To: T10 Technical Committee
 From: Rob Elliott, HP (elliott@hp.com)
 Date: 17 July 2006
 Subject: 06-189r3 SAS-2 Allow table-to-table expander attachment

Figure 15 — Expander route index levels example

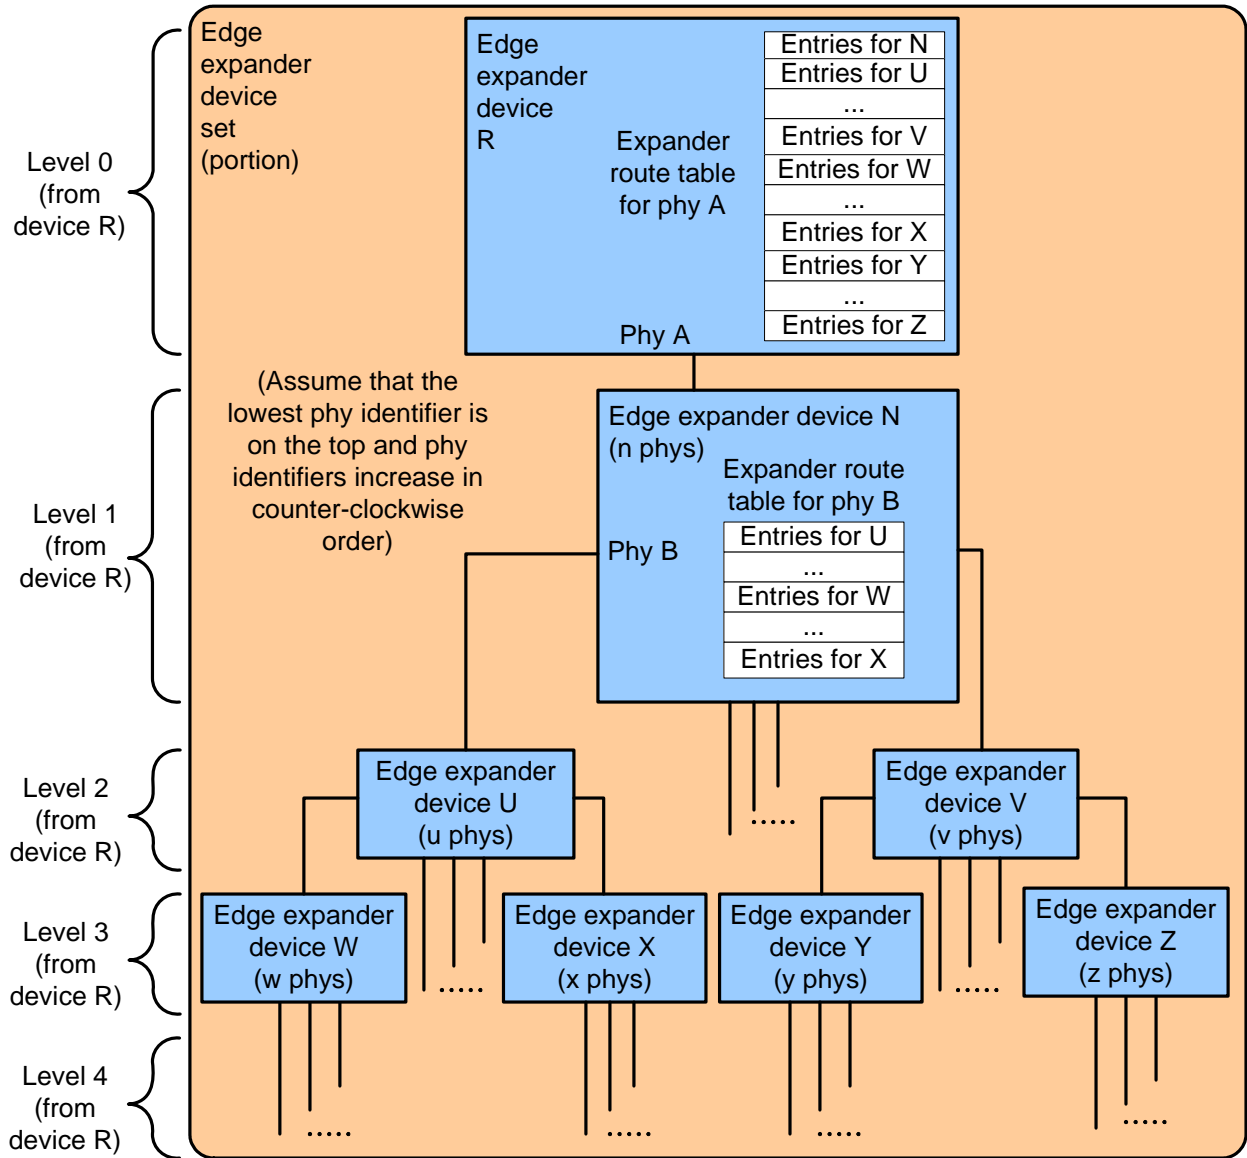
Editor's Note 4: Delete "edge" in that figure

Figure 16 — Expander route index levels example with ~~fanout~~ expander device

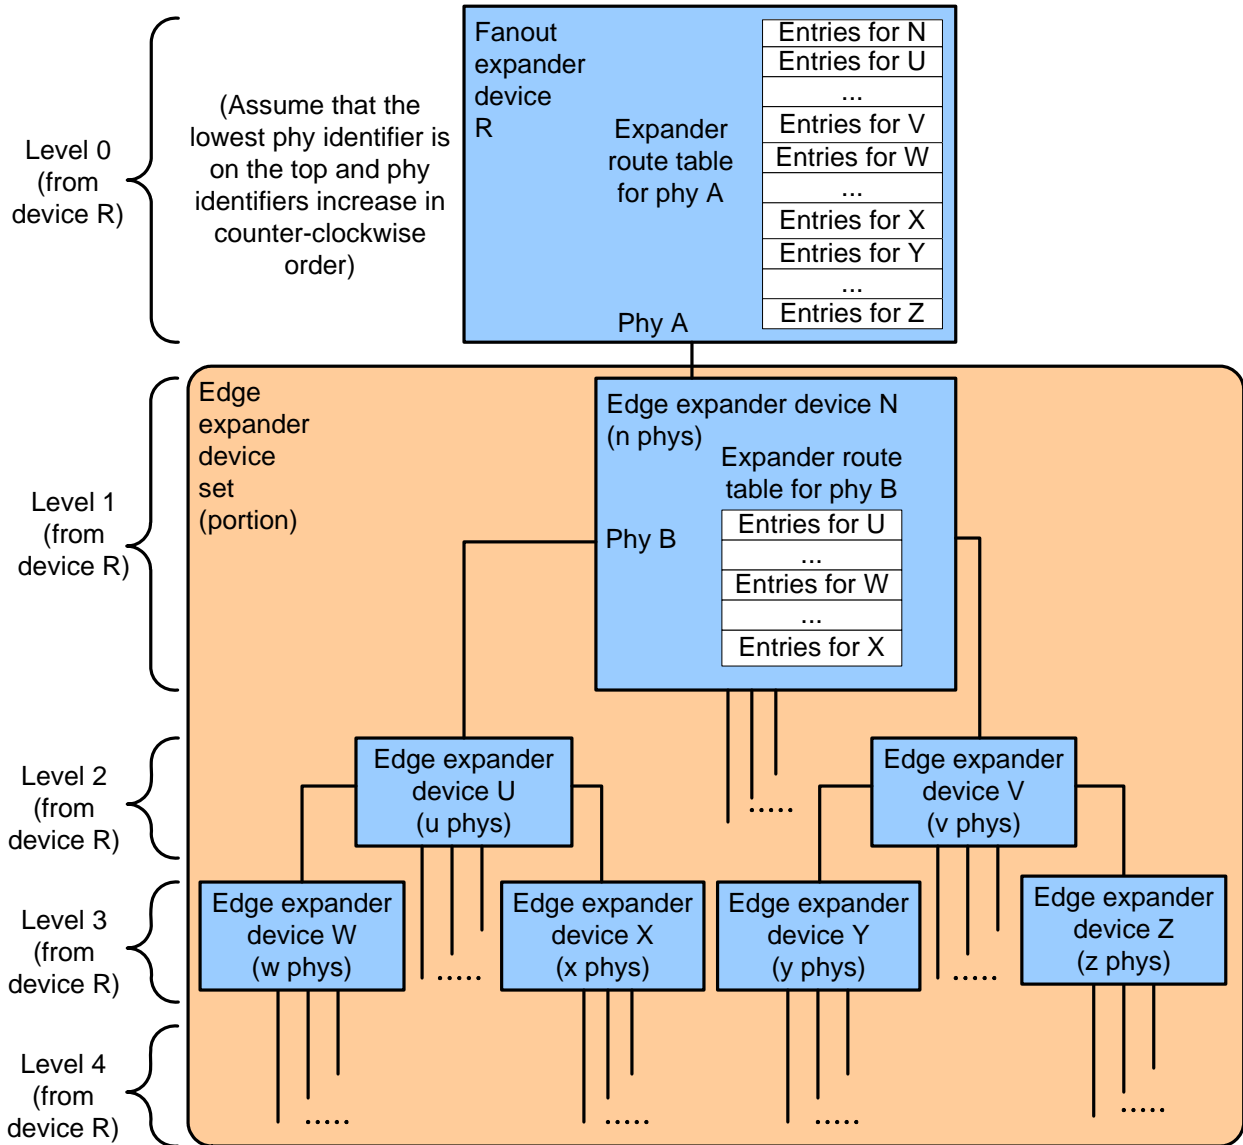
Editor's Note 5: Delete "edge" in that figure

Figure 17 — Expander route index order example

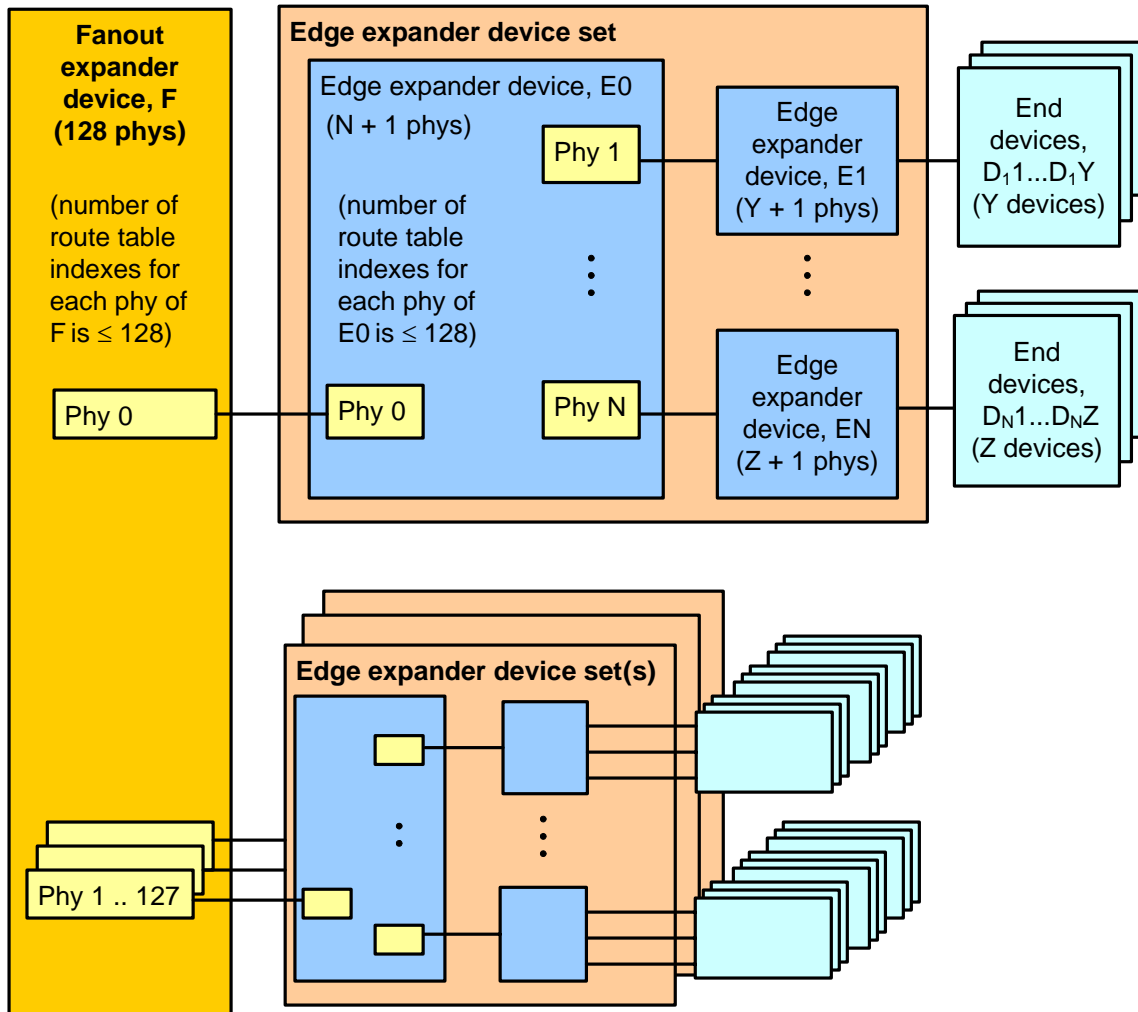
Editor's Note 6: Delete "fanout" and "edge" and the "set" concept in that figure

Figure 20 — Mini SAS 4x receptacle connector - end device [or enclosure universal port](#)

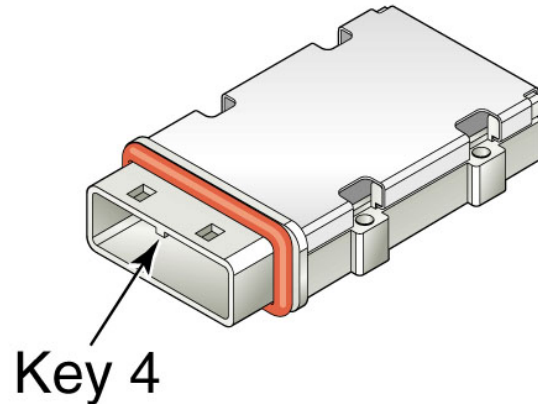
Figure 20 shows the key on a Mini SAS 4x receptacle connector used by end devices. This connector may be attached to the Mini SAS 4x cable plug shown in figure 18 or the Mini SAS 4x cable plug shown in figure 19 (see 5.2.3.3.2.2).
